Building Permit Application

Project Name: ICU 3RD FLOOR MEDICAL CENTER OF Aurora

CITY OF AURORA
BUILDING DIVISION
APPROVED AS NOTED
DATE SEP 2 2 2011
11-563087

PROJECT
3RD FLOOR
EAST TOWER B

SHEET NUMBER
A-1

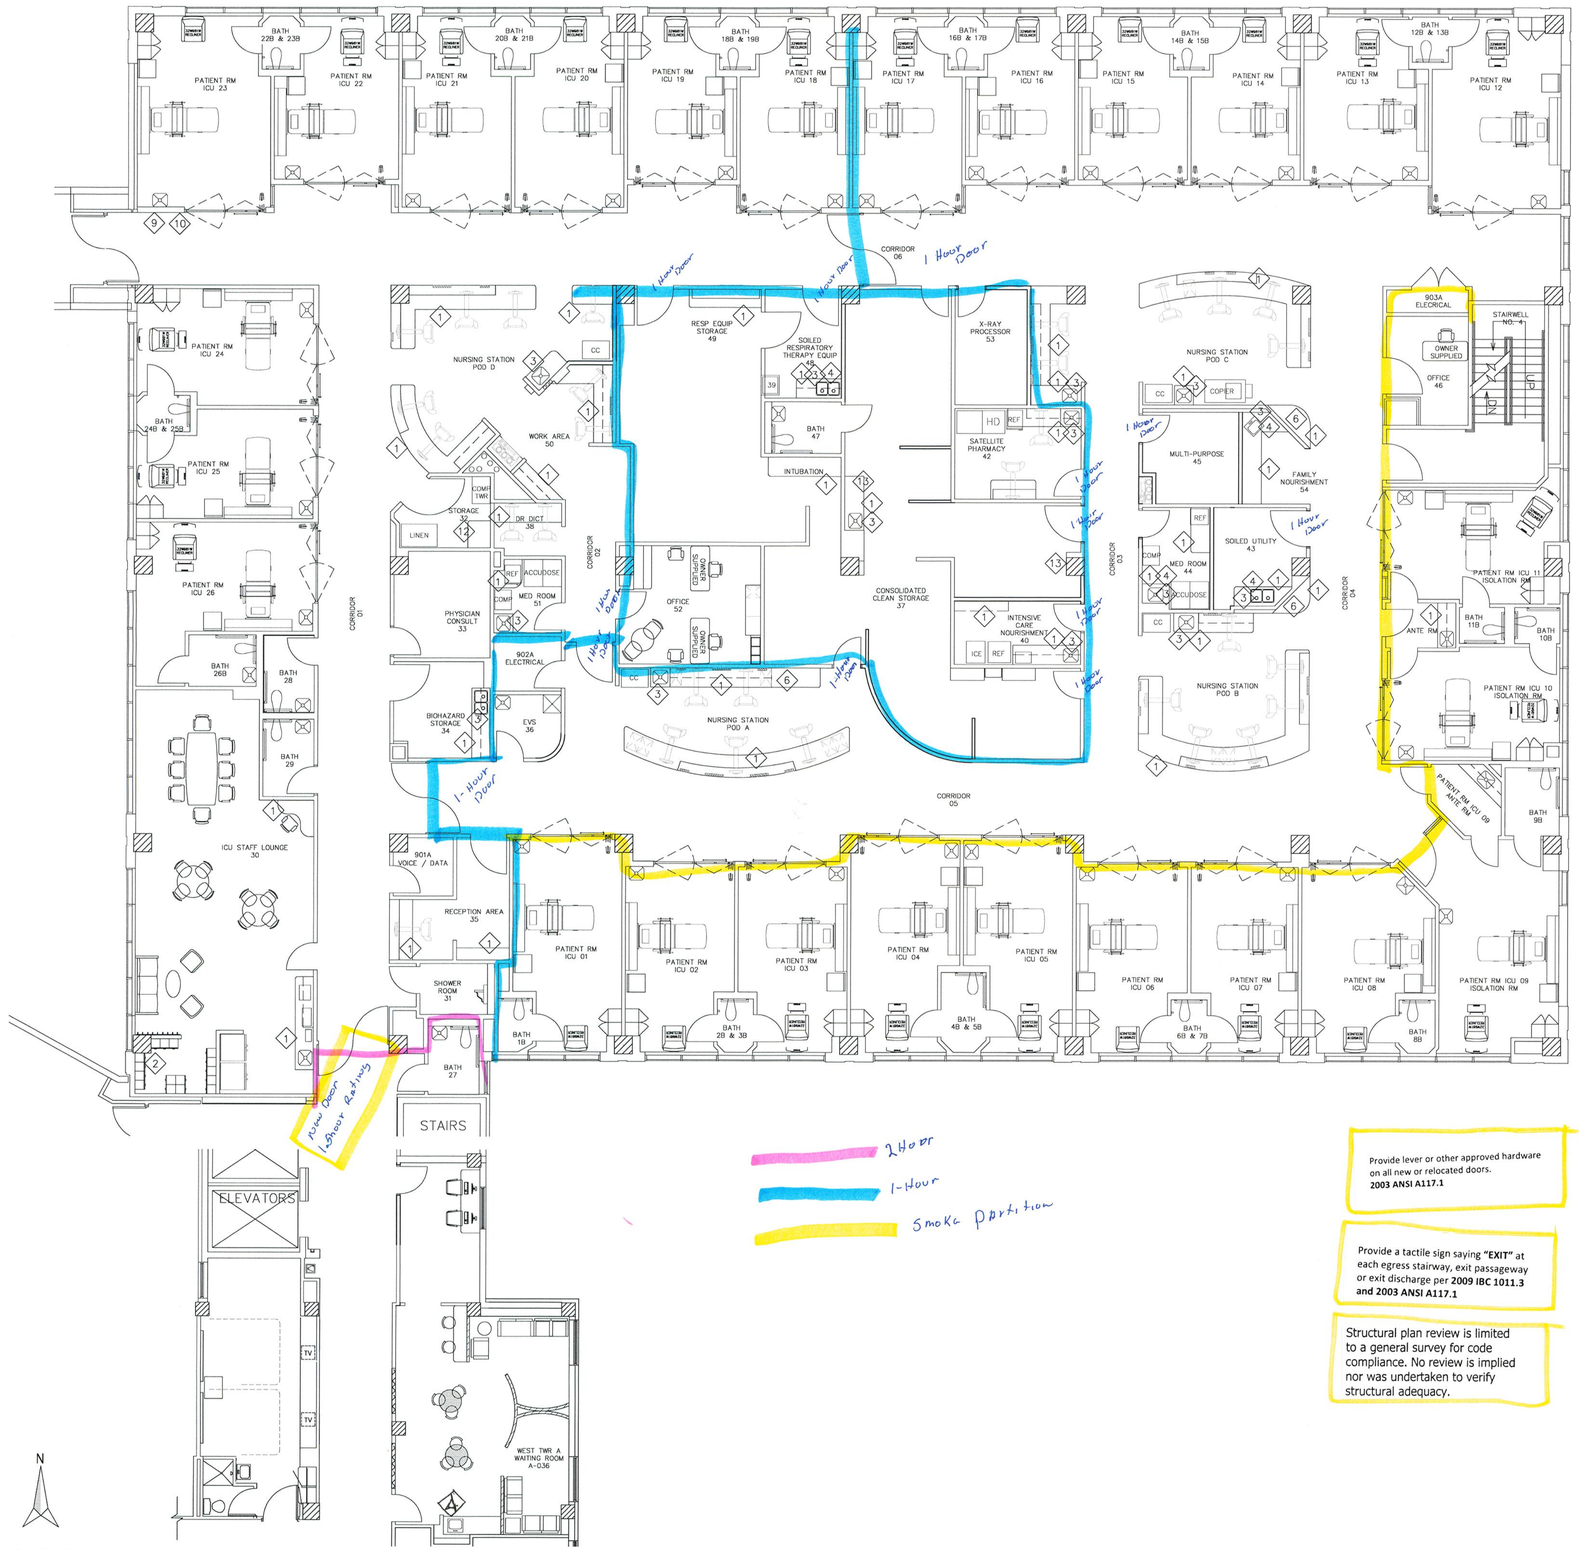
Code violations that are found during inspection are required to be corrected. Permit issuance does not grant approval of a code violation **2009 IBC 105.4**

SHEET NUMBER
A-3

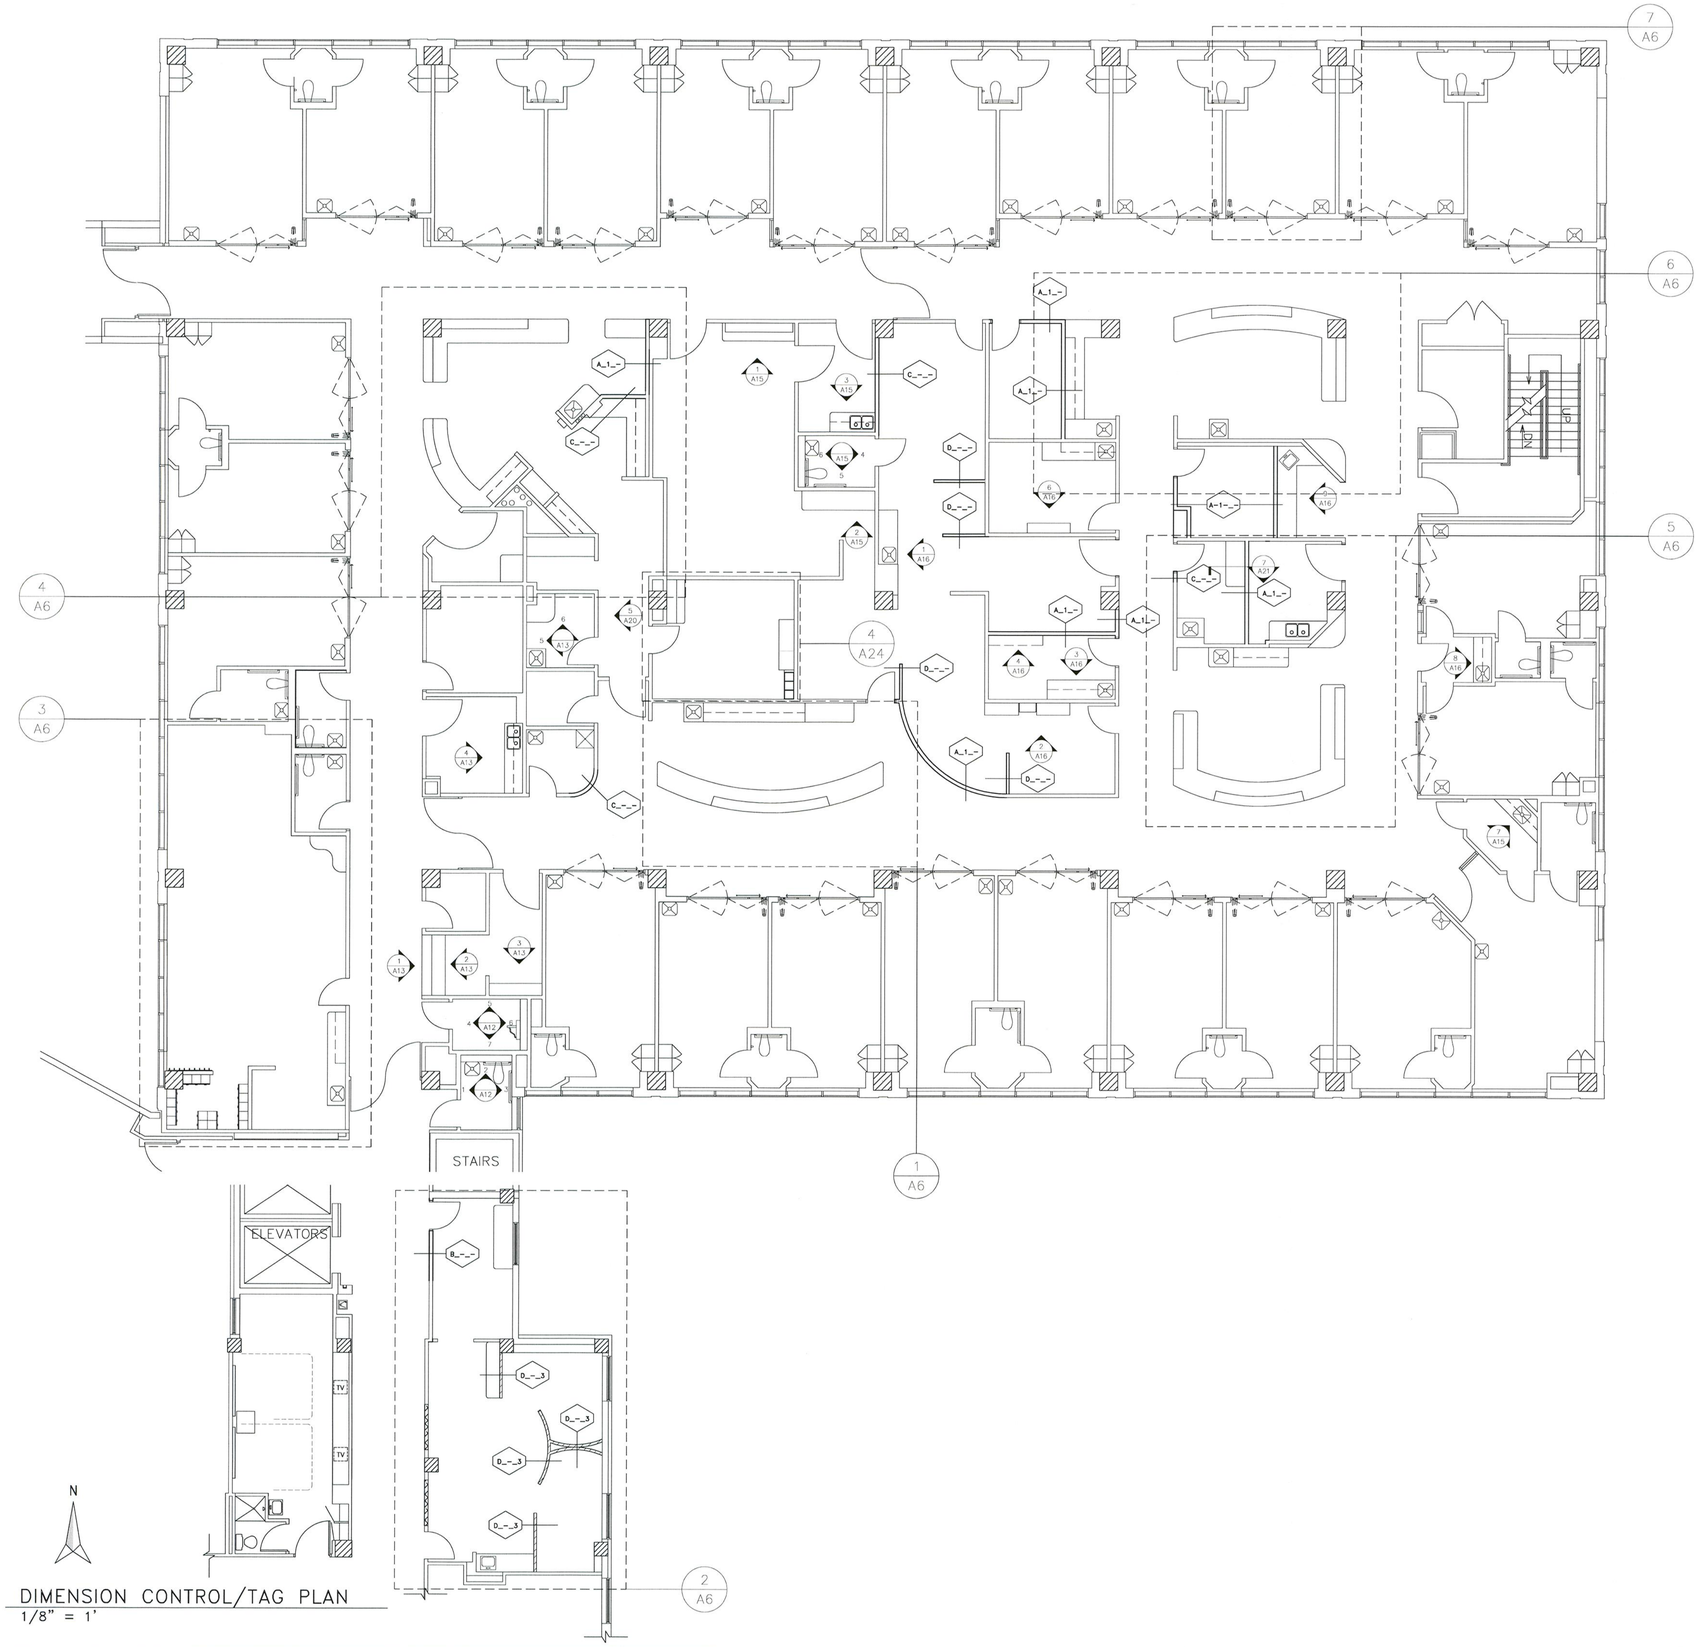
After hours inspection to verify required egress illumination may be required during field inspection. **2009 IBC 1006**

Re Lamp Existing Fixtures Using Lower Wattage Fixtures.

SHEET NUMBER
A-21

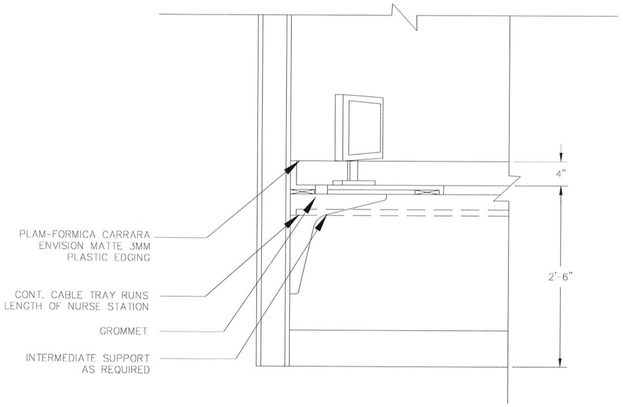
Concrete wood structure
To be Fire Retardant Treated
ONLY

SHEET NUMBER
E-1

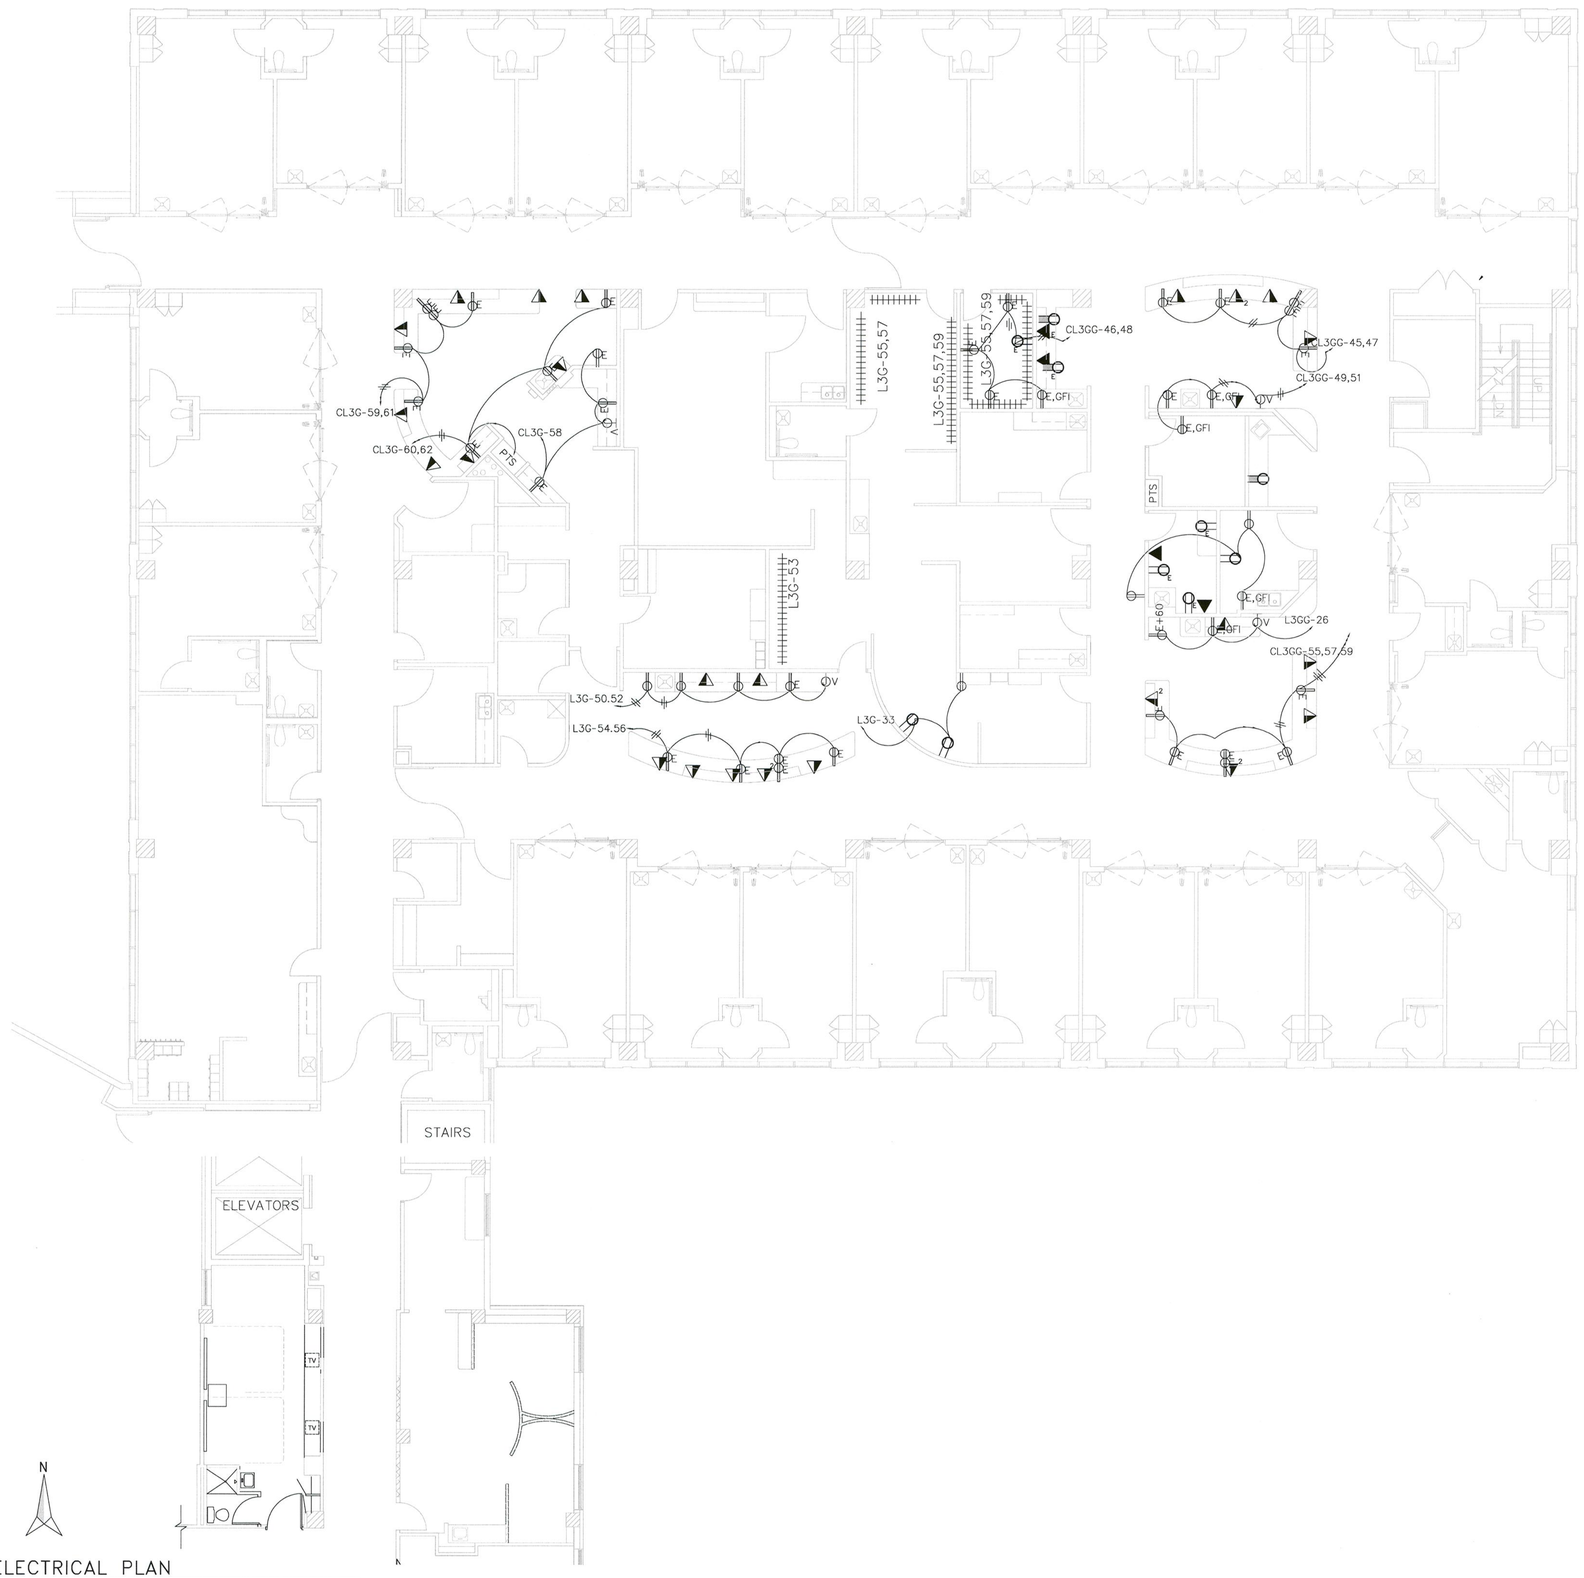
Relocate existing circuits
